Technical Bulletin T562

Product: DVD Player

Hardware Technical Bulletin: H2004-01

Subject: POPPING NOISE

Figure 1

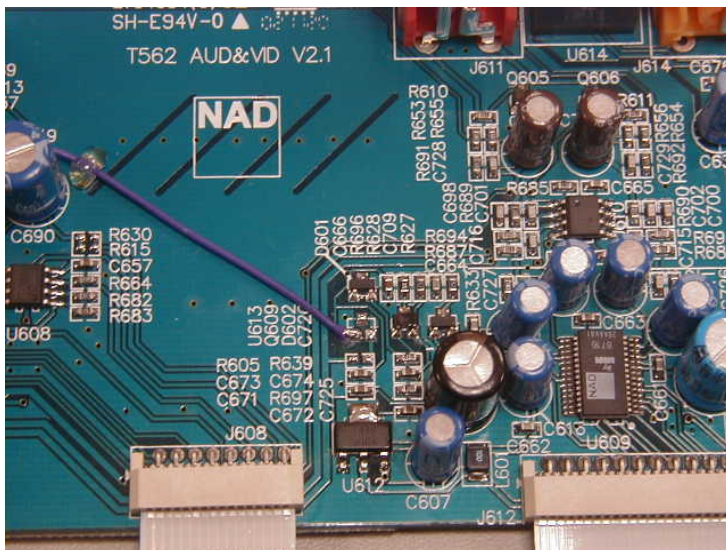
DESCRIPTION: You may have a complaint that when turning the unit on from the front panel, a pop noise is heard from the analogue audio output.

REASON: The muting circuit is not activating during the first 1/4 second of operation.

SOLUTION: Identify the AUDIO VIDEO pc board as VER. 2.0 or 2.1.

For VER. 2.1 remove U613 and R605, located near the right side of the video socket J608, as shown in Figure 1.

For VER 2.0 remove only U613, located near the right side of the video socket J608, as shown in Figure 1.

Solder a wire from U613's pin 1 (solder pad closest to J608) to Q501's emitter leg as shown in Figure 1 and Figure 2.
